P-6887

21211

ISSUE (2) :-

PARTY'S NAME	PRAYOSHA ENTERPRISES LTD., UGANDA
PARTY'S DRAWING No.	AS PER DRAWING
ALLOY & TEMPER	6063 T6
DESCRIPTION	WINDOW SECTION

NAME	DATE
DRAWN	J.P.KAUSHIK	11-06-2015
CHECKED		
APPROVED	S.S.GARG	17-06-2015
SCALE		1:1
AREA mm ²		255.103
PERIMETER mm.		419.008
WEIGHT kg/m		0.689
DRAWING No.	SECTION No.	
P-6887	-	
21211	21211(ISSUE-2)

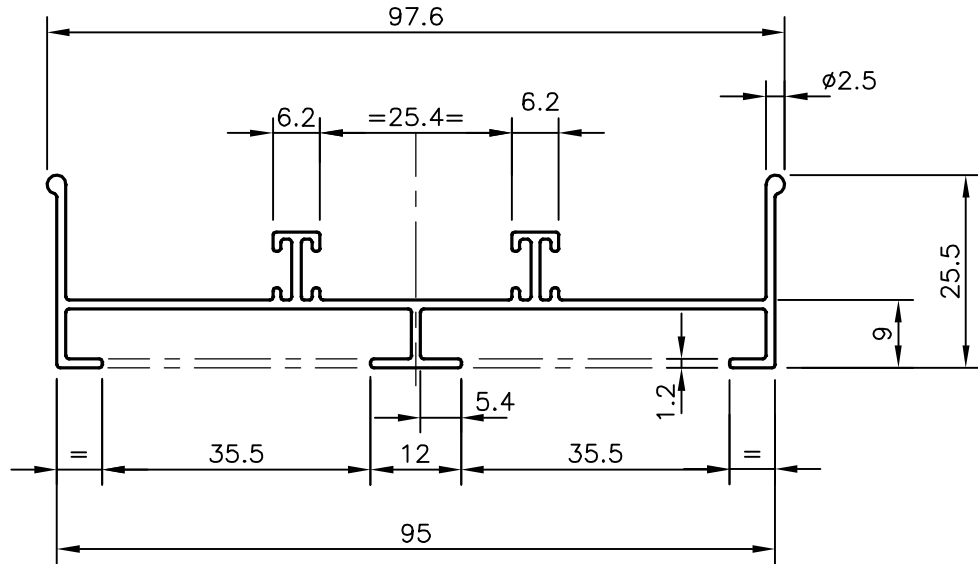
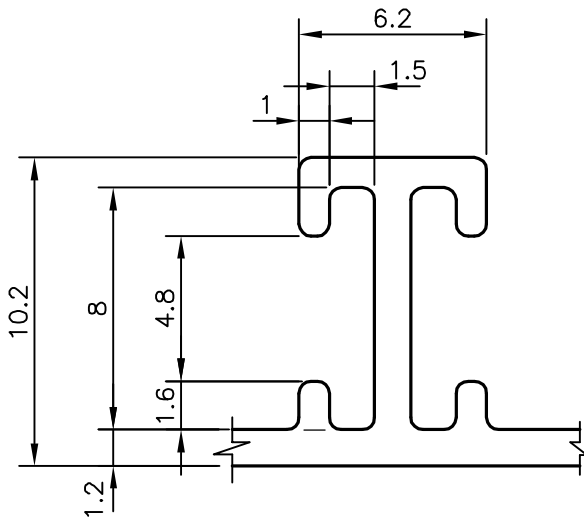
∅2.5- 2 BULB ADDED ACCORDINGLY DIMENSION ALSO CHANGED FROM 24 TO 25.5 mm AT BOTH ENDS.

WEIGHT ALSO CHANGED FROM 0.666 kg/m. TO 0.689 kg/m.
